Re: Cell 4B Lining System Design Report, Response to DRC Request for Additional Information
– Round 3 Interrogatory, Cell 4B Design.

We are responding to your September 4, 2009 letter requesting additional information regarding the Cell 4B Design Report.

**Subject: Blast Plan Review
 Cell 4B Construction
 White Mesa Mill
 Blanding, Utah**

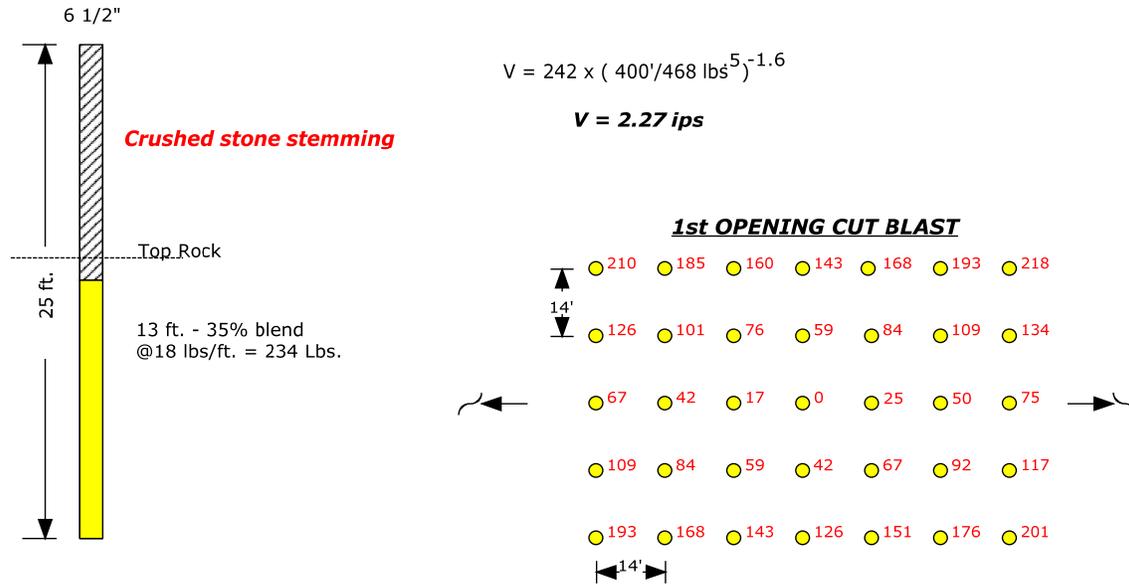
Concerns about the ground response at the existing berms that border this new construction require limitations as follows:

- 1) 5 inches per second when blasting further than 100 ft. from the berm.
- 2) 2 inches per second when blasting within 100 ft. of the berm.

The seismographs should be placed at or near the water line on the pond side of the Berm.

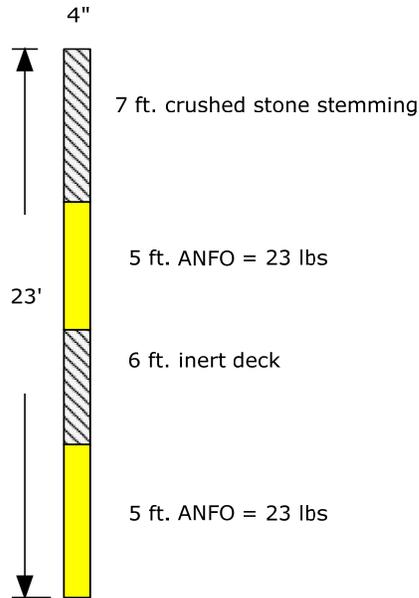
When blasting nears the berm areas, a decision by Denison must be made in reference to the State imposed vibration restrictions. The following is an illustration of the blast hole design (decked) needed to ensure the compliance to the vibration limits.

$$V = 242 \times (100'/23\text{LBS})^5 \cdot 1.6$$

$$V = 1.88 \text{ IPS}$$

It is essential to the non-duplicating of nominal firing times, that electronic detonators are used. Each explosive deck in the hole will be fired at different times. The pattern will be a 9' x 12' and a 4" hole will be used.
